## **ALABAMA PECAN SUBDIVISION, PHASE 1**

APPLICATION NUMBER 4 DATE April 19, 2018

APPLICANT Alabama Pecan Subdivision, Phase I

REQUEST Subdivision

# DETAIL SITE PLAN

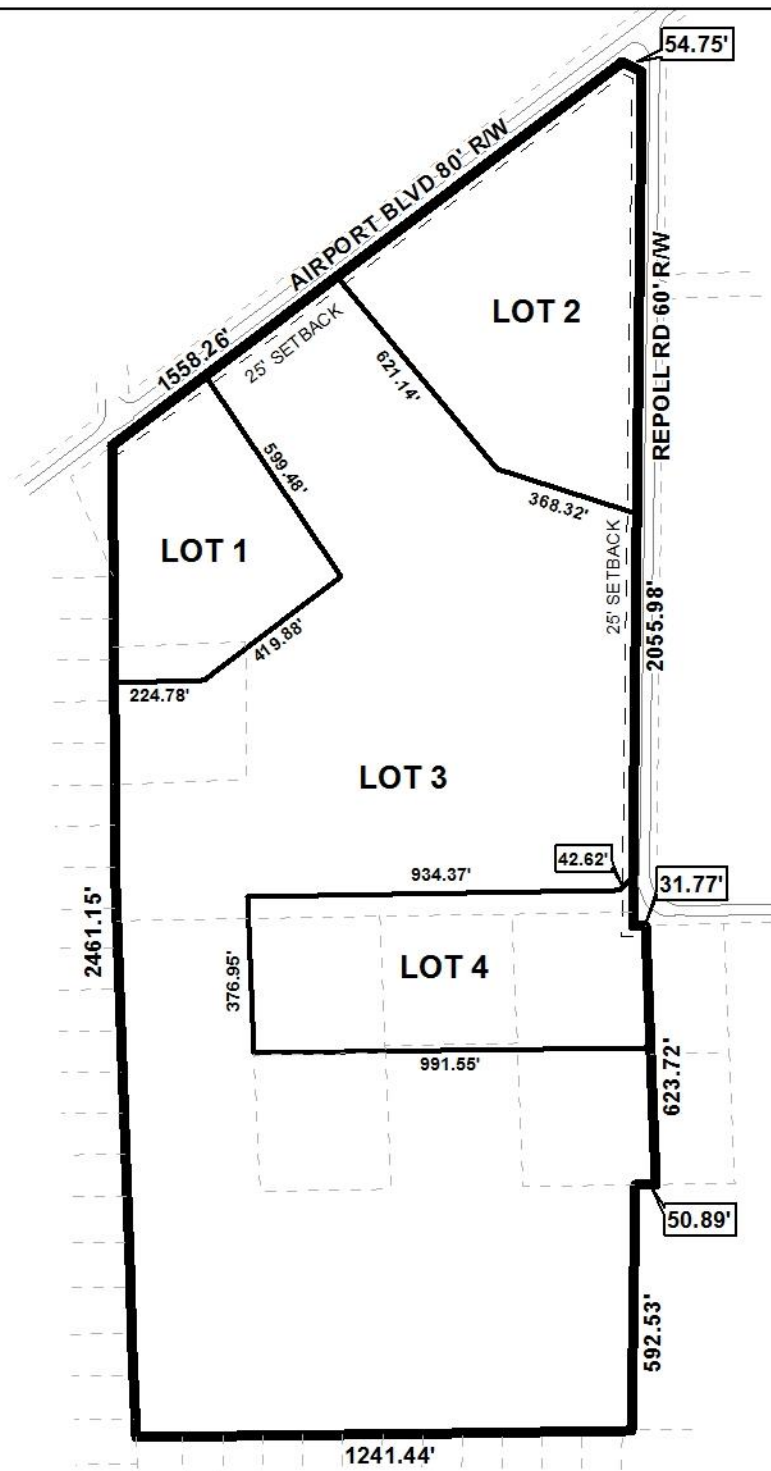
The site fronts Airport Boulevard and Repoll Road. Airport Boulevard is a proposed major street with a planned 100' right-of-way, as illustrated on the Major Street Plan. However, the plat indicates the right-of-way width of Airport Boulevard as 80'. Therefore dedication of any necessary right-of-way to provide 50' from centerline of Airport Boulevard will be required. The plat depicts Repoll Road as having a 60' right-of-way; therefore no dedication will be required.

The site is bounded along the west side by a proposed major street, a new connection linking Eliza Jordan Road to Johnson Road West. The right-of-way is proposed to be 100 feet, thus the plat should be revised to reflect dedication of the right-of-way.

*It should also be pointed out that a revised plat depicting any provision for the proposed major street was not submitted.*

Based on the preceding, the application is recommended for Holdover to April 19<sup>th</sup> with a revised plat reflecting the proposed Eliza Jordan Road major street extension to be submitted by Wednesday, March 28<sup>th</sup>.
